STAFF REPORT
COMMUNITY DEVELOPMENT DEPARTMENT

HEARING DATE: 9/17/2020
 TO: Mayor & City Council
 FROM: Joe Dodson, Associate Planner
 208-884-5533
 SUBJECT: H-2020-0067
 Jocelyn Park Subdivision

Request for Preliminary Plat approval of 67 single-family residential lots and 7 common lots in an existing R-8 zoning district.

A. Preliminary Plat (dated: July 17, 2020 / 9/08/2020)

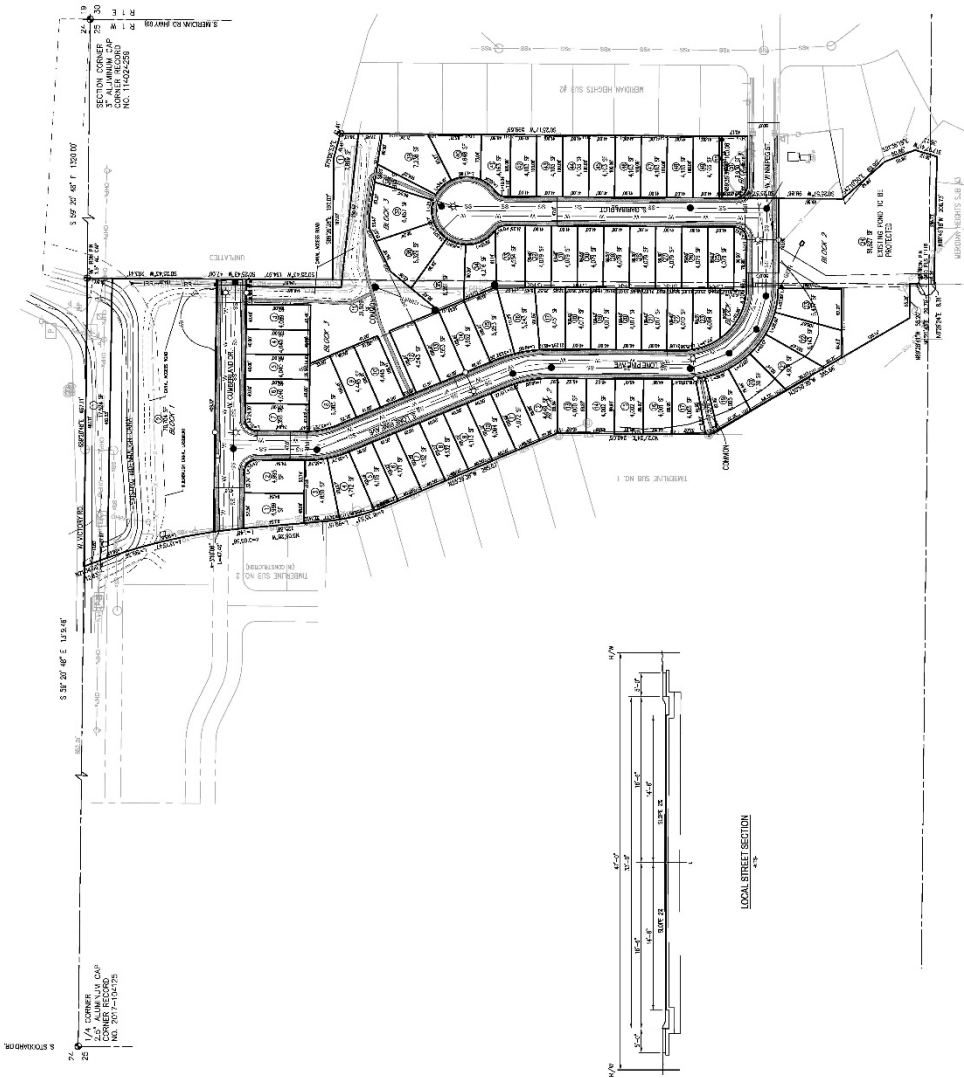
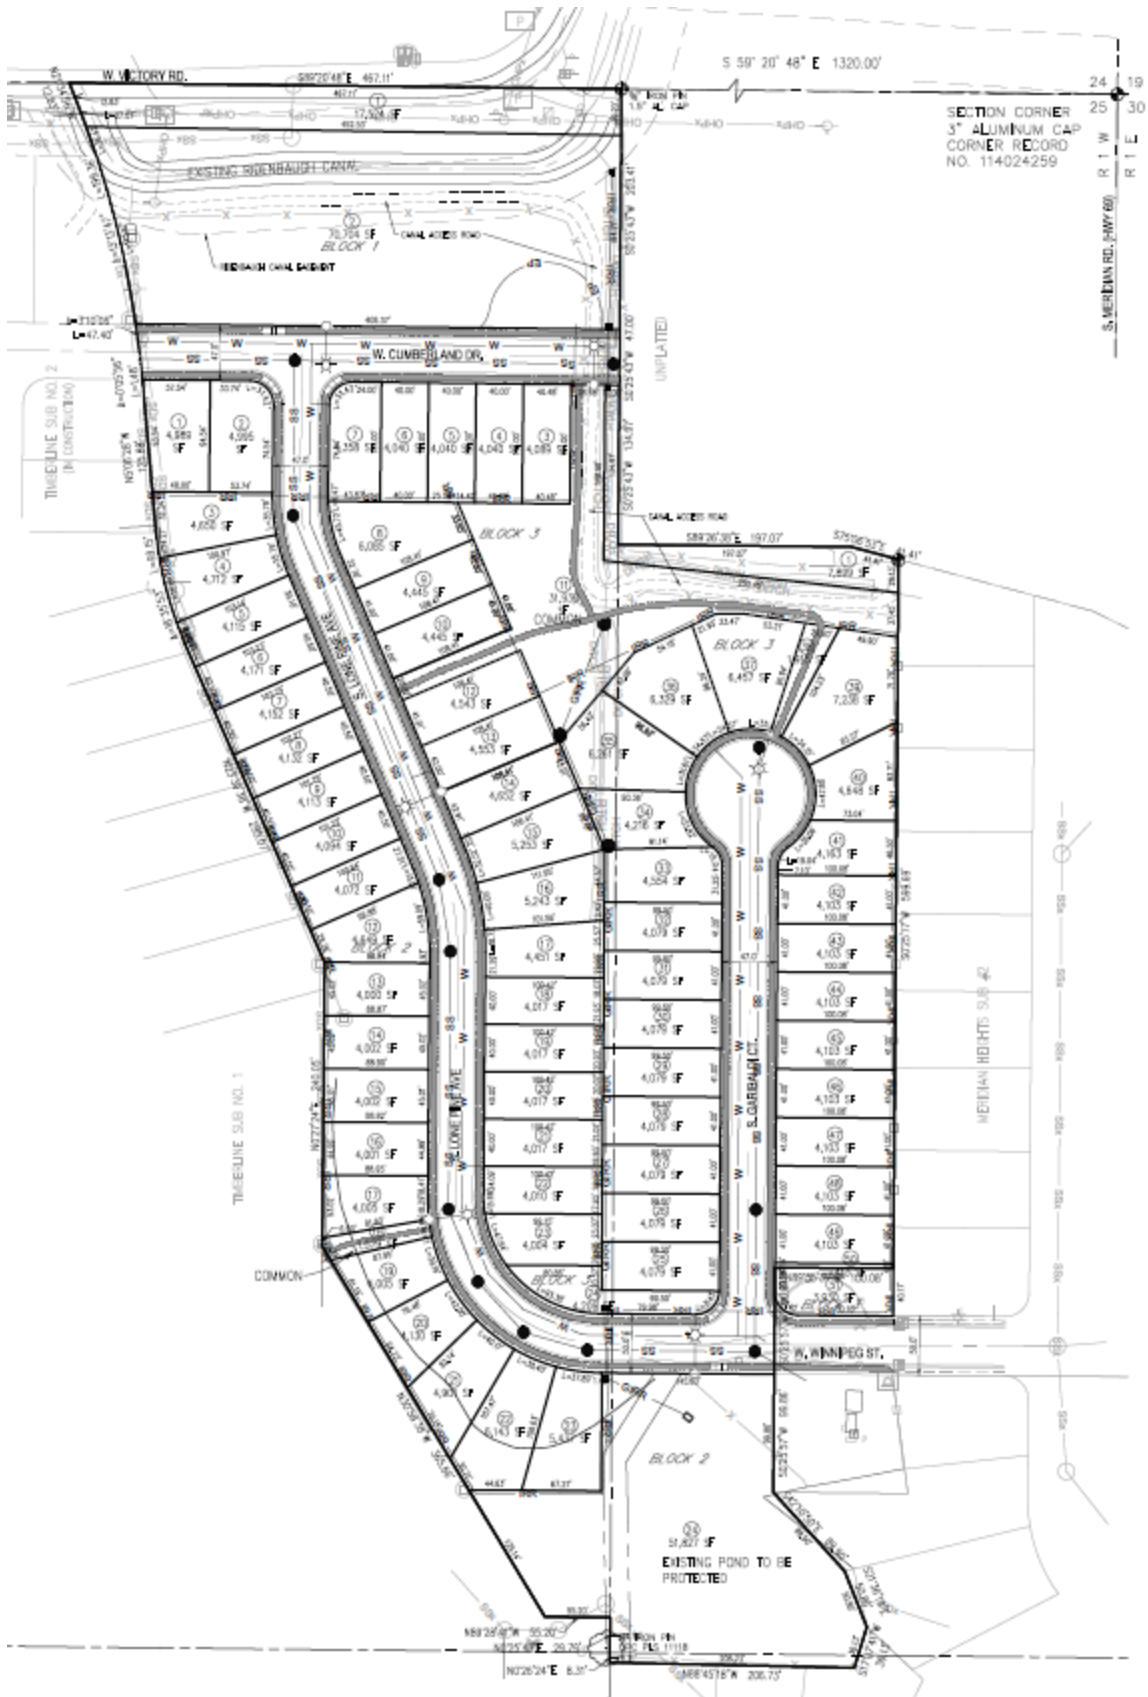
Staff supports the addition of micro-pathways throughout the development but has some concerns regarding their placement. First, Staff believes the micro-path connection from the central open space lot to the western street should be relocated two lots further north, between Lots 10 & 11, Block 3 to help with potential visibility issues and crime prevention. Second, Staff has concerns over how the pathway within the large open space lot along the Ridenbaugh Canal is depicted on the submitted plans and where it shown to connect to the Timberline Subdivision to the west. The Timberline lot directly abutting the subject site in the northwest corner is a buildable lot and will have a privacy fence on the shared property boundary. Therefore, the proposed layout of the pathway shown would likely never become a reality. The only other pedestrian access out to Victory Road from this site would be via the irrigation district access road but this is not supported by staff nor the irrigation district at this time. This access road will likely be fenced off from this open space lot to ensure a safer open space area along the canal. Because of these issues, staff proposes that the proposed pathway be completely out of the irrigation district easement and looped around this northern open space lot for a walking path around the perimeter of the lot and connect back to the proposed sidewalks along the extended W. Cumberland Drive.

An area of additional concern for Staff is the open space area directly north of Lots 35-37, Block 3 (the lots at the end of S. Garibaldi Court in the eastern half of the site). The Applicant is proposing to leave an area of open space between the rear yards of these three homes and the irrigation district access road. The access road must be fenced off from this development which leaves a thin area behind homes with the only true visibility coming from the open vision fencing of these three homes' rear fence. This area leads to nowhere and does not appear to offer any usable benefit for the development if left as is. Even with the required open vision fencing along the rear of these lots, Staff is concerned this area of open space will be neglected due to the slope of the terrain and its location. Therefore, Staff is recommending that this area be added to the adjacent lots, Lots 35-37, Block 3, instead of remaining open space. The open space calculations should then be revised to remove this area from the calculations table.

- a. ~~Revise the plat to include some of the area behind~~ rotate Lots 35-37 and 36, Block 3 to the west and subsequently move the proposed micro-pathway to the east to make the open space area behind them more usable and accessible, as part of these building lots instead of common open space up to the boundary of the irrigation district easement.

- b. ~~Revise the plat to show the micro-pathway to be located between Lots 10 & 11, Block 3 instead of between Lots 12 & 13, Block 3.~~
 - c. Revise the plat to show the additional right-of-way along W. Victory Road as required by ACHD; this should include a 5-foot wide sidewalk located at least 31-feet from centerline.

B. Open Space Exhibit (date: 6/2/2020)

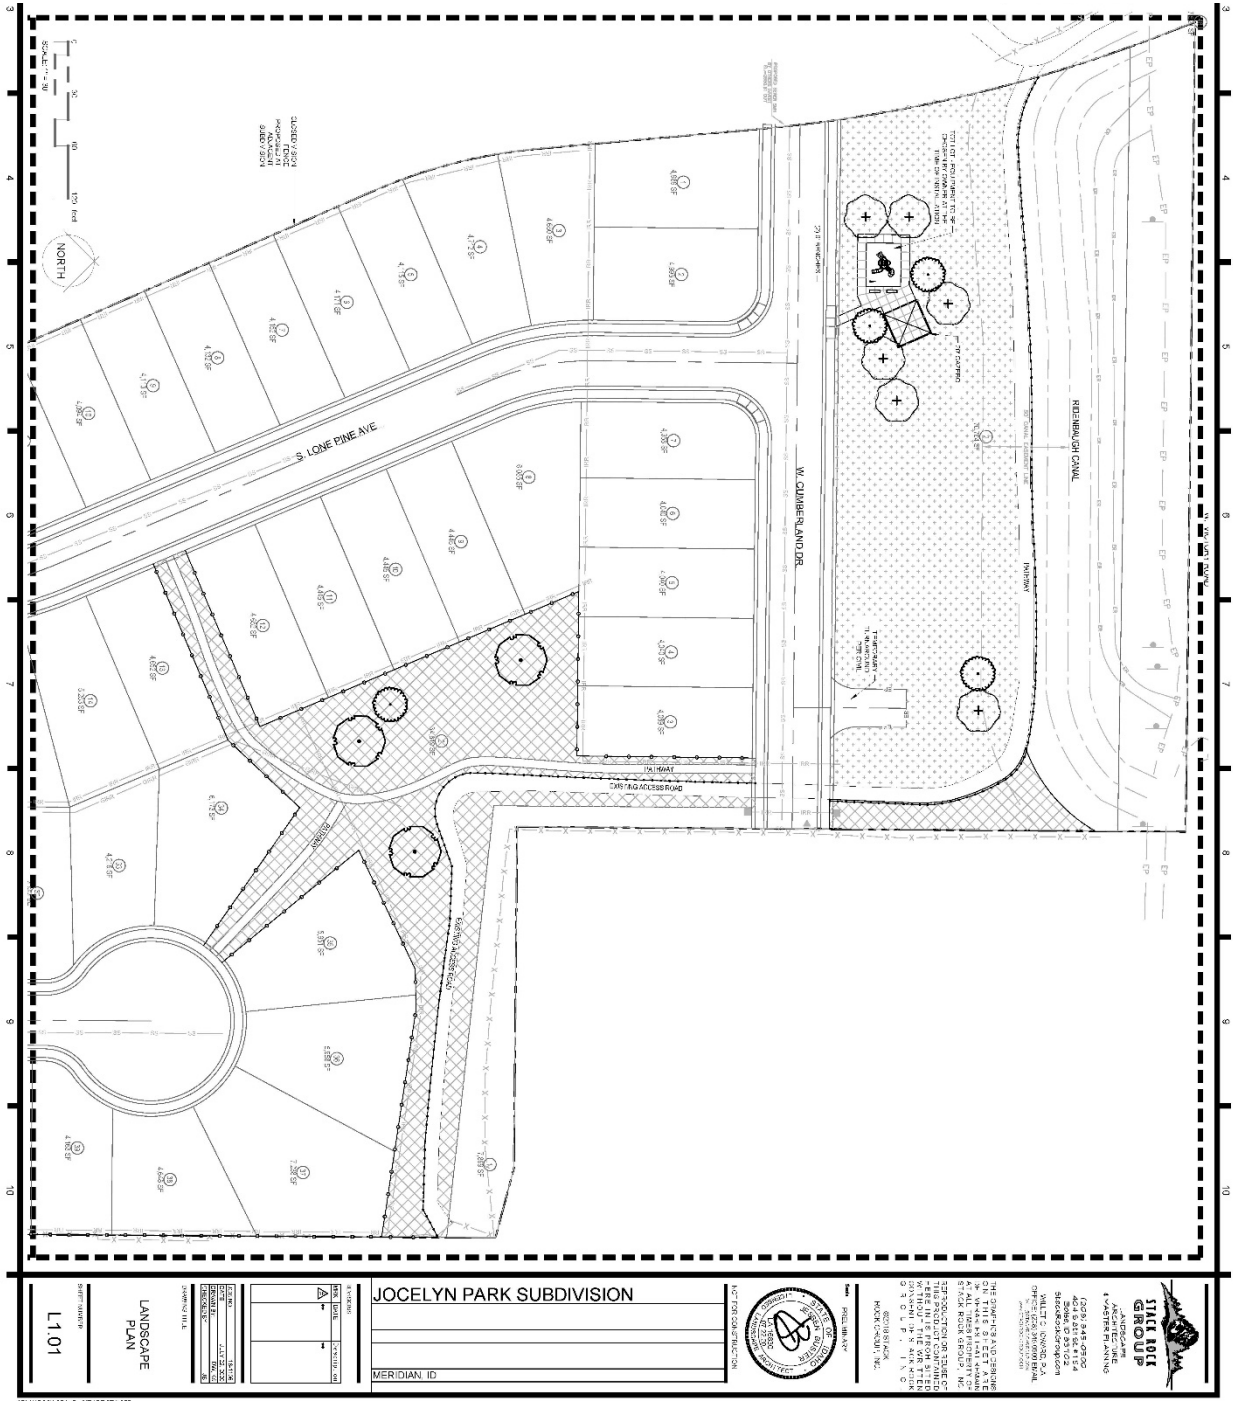
According to the open space exhibit (see Exhibit VII.B), the applicant is proposing a total of 3.65 acres of open space. The exhibit shows three (3) distinct areas of open space: one area in the south that contains the pond; one area along the entire northern boundary of the subject site; and one centralized area. The large open space lot containing the pond abuts open space area in the Timberline No. 1 subdivision currently under construction. In addition, there is an end cap lot and a micro-pathway connection to the west shown on the open space exhibit. The submitted open space exhibit shows all of this area as qualifying but upon Staff's review, some of this area is not qualifying.

The existing pond is more than 25% of the lot in which it resides and therefore the entire lot is not qualifying open space per the standards listed in UDC 11-3G-3B.7. The other area of open space that is listed as qualifying but is indeed non-qualifying is the end cap lot located at the south end of the lot (approximately 4,200 square feet) directly north of the pond. This area meets neither the 50' by 100' dimensions nor the 5,000 square foot minimum size in order to count towards the qualified open space. After removing the end cap lot and the lot containing the pond from the open space calculations, there are 2.46 acres of area that is all qualifying open space. Staff is recommending a condition to revise the open space exhibit prior to the City Council hearing to ensure a clean record.

3. The Open Space Exhibit and calculations table shall be corrected as follows at least ten (10) days prior to the City Council hearing:
 - a. Revise the calculations table to show the correct amount of qualified versus non-qualified open space in accord with UDC 11-3G-3.

- b. Revise the open space exhibit ~~to show and calculations table to remove that area behind~~ Lots 35-37 and 36, Block 3 rotated to the west and the micro-pathway relocated to the east to match the revised preliminary plat layout up to the boundary of the irrigation district easement.

- c. Revise the open space calculations to remove that area where the required temporary turnaround is located on the common open space lot, Lot 2, Block 1.

C. Landscape Plans (date: 7/22/2020)

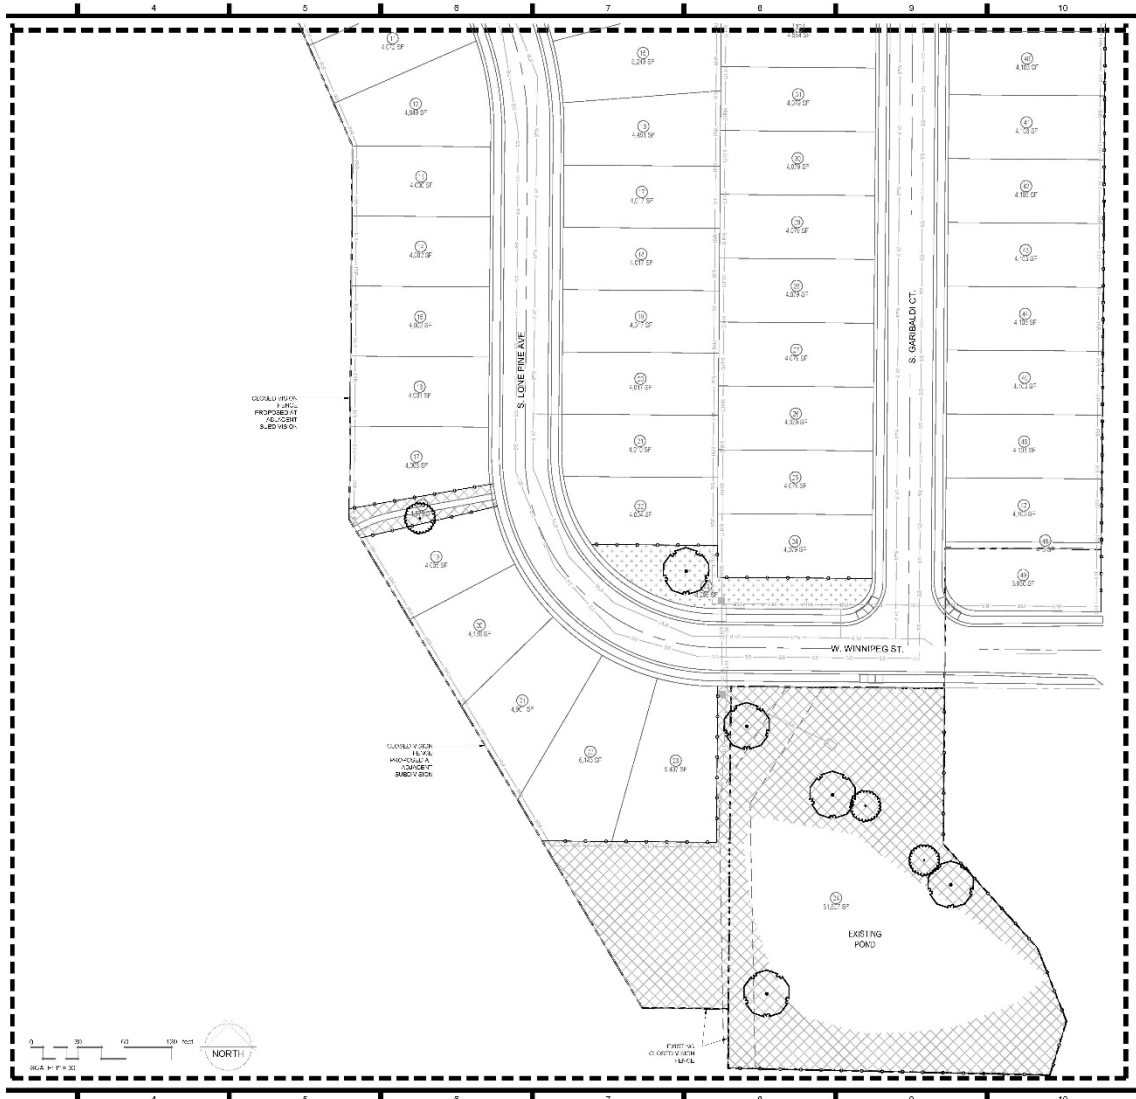
Although the correct number of trees are shown on the landscape plans and within the calculations table, the required shrubs and other vegetative ground cover is not depicted on the landscape plans. Therefore, Staff is recommending a condition of approval to show the required shrubs along the micro-pathways per UDC 11-3B-12C.2.

The non-qualified open space area containing the pond (Lot 24, Block 2) abuts open space in the adjacent Timberline subdivision, as noted above. This area of open space was not fenced by the developer of Timberline No. 1 and Staff supports no fencing along this shared boundary to allow better integration of both open spaces as required by the UDC. The submitted landscape plan shows closed vision fencing along this shared property line which is not in line with the UDC. Staff is recommending a condition of approval to remove the fencing in this area so that the open space is continuous between the two developments.

The proposed children's play structure located in the north open space lot should also be fenced off from the Ridenbaugh Canal to ensure an area of safe play for everyone within the development. The only fencing shown on the submitted landscape plans in this area is a fence on the north side of the irrigation district access road. As noted in the comments from the Parks Department, the fence should be on the south side of the access road, in order to separate the access road from the open space and proposed play structure. Therefore, Staff is recommending a condition of approval to correct this and show the fencing on the opposite side of the access road.

2. The landscape plan included in Section VII.C, dated 06/18/2020, shall be revised as follows prior to Final Plat application submittal:
 - a. Revise the landscape plans to show shrubs and other vegetative ground cover to the areas along all pathways in accord with UDC 11-3B-12C.

- b. Revise the landscape plans to show the fencing along the Ridenbaugh Canal to be on the south side of the irrigation district access road and maintain accordance with UDC 11-3A-6 to separate the open space and play structure from the canal.

- c. Show the micro-pathway to be located between Lots 10 & 11, Block 3 instead of between Lots 12 & 13, Block 3.
 - d. Show the required sidewalk along W. Victory Road.

- e. ~~Remove~~ Revise the fencing shown along the western subdivision boundary located on the common open space lot, shown as Lot 24, Block 2, to include a break in the fencing to allow for the adjacent open space to be continuous with this open space lot.

- f. An amenity that adds seating shall be added to the open space lot containing the open water pond, shown on Lot 24, Block 2.
 - g. Revise the landscape plans to reflect the revised plat layout.
